ADDENDUM #02

PROJECT:	SJRSC – Library Renovation	DATE:	02/05/2024
OWNER:	St Johns River State College	PROJECT NO.:	23025
CONTRACTOR:	TBD

The information contained in this **ADDENDUM 02** shall supersede the construction documents issued on 10/26/2023 and all previously issued Addendums.

NOTES, SYMBOLS, & LEGENDS

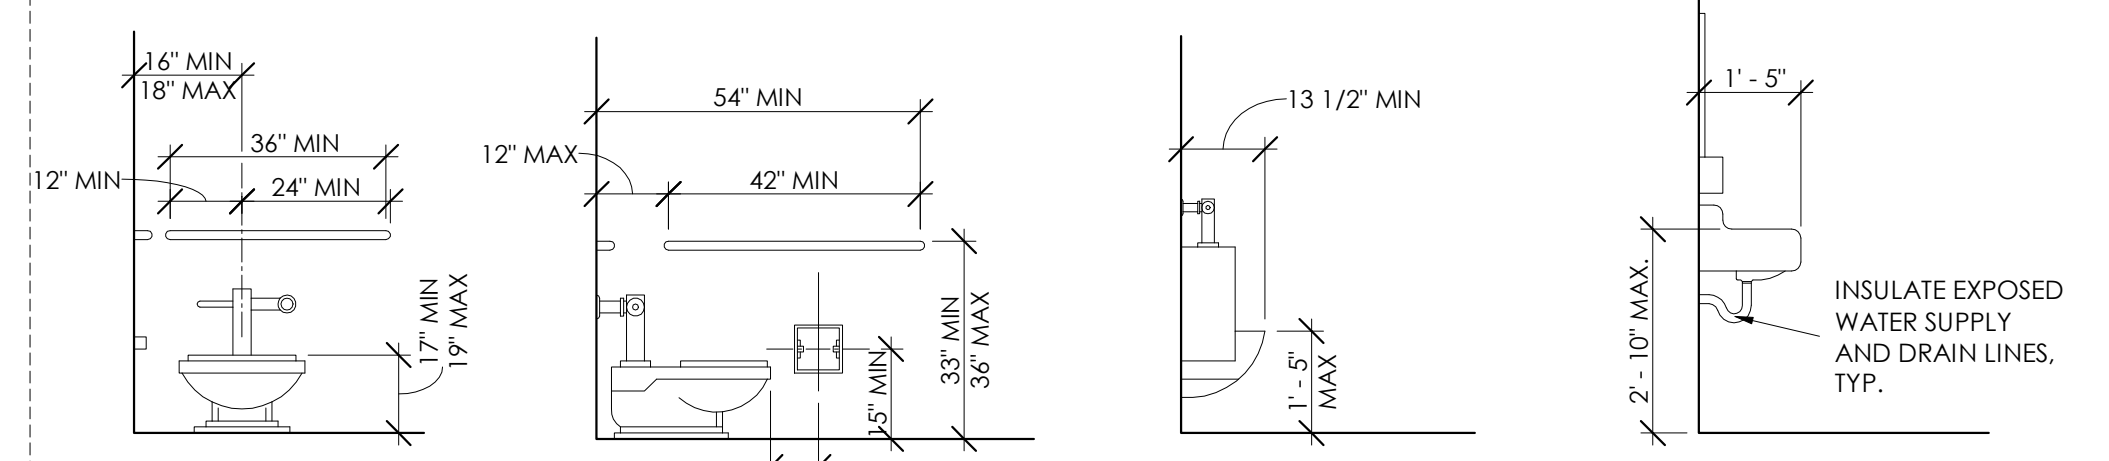
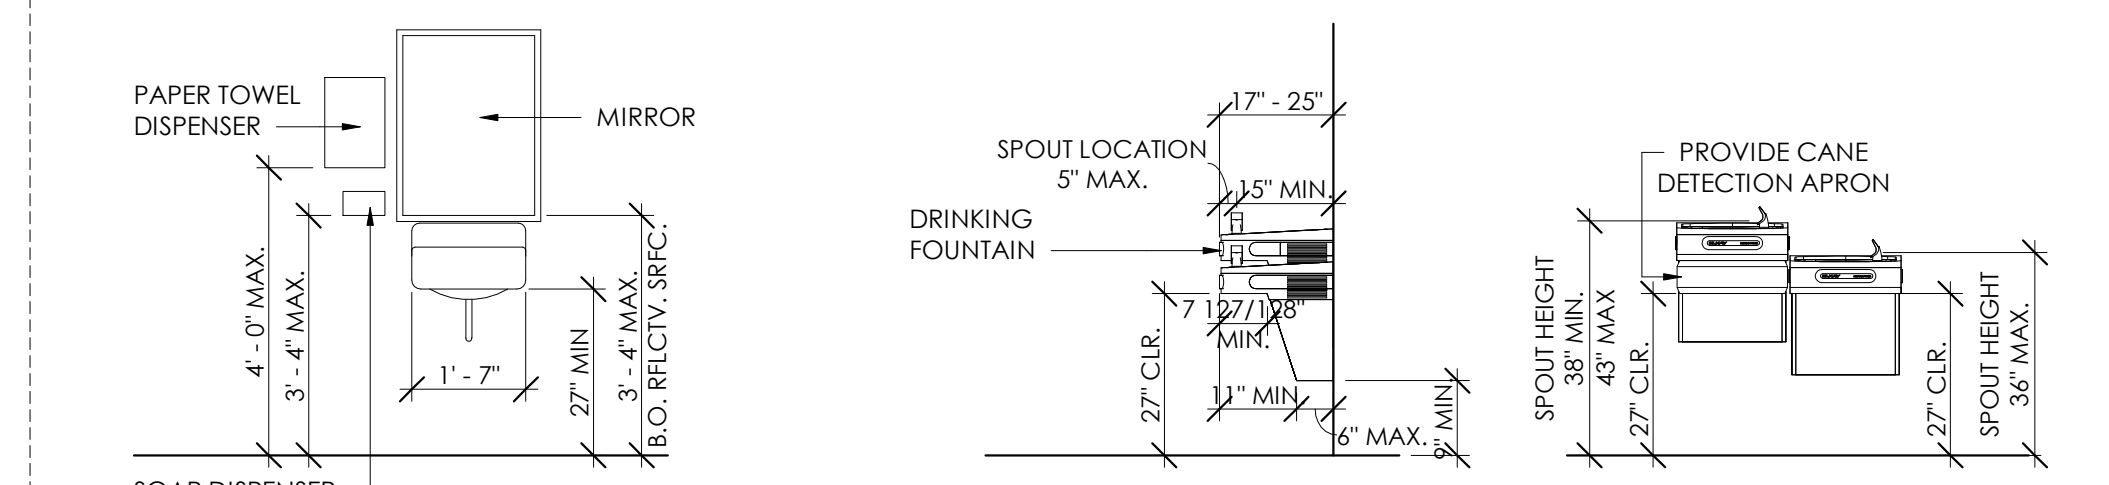
- A0.1** (Notes, Symbols, & Legends). Drawing index updated.
- A0.5** (Demolition Floor Plan). Demolition picture updated to show greater area being removed. Note added on picture.
- A9.0** (Finish Legend & Schedule/Finish Plan). Roller shade product added to finish legend.
- S1.01** (Second Floor and Roof Plan). Drawings updated to match architectural drawings. Lintel note removed. Detail changed to not used.
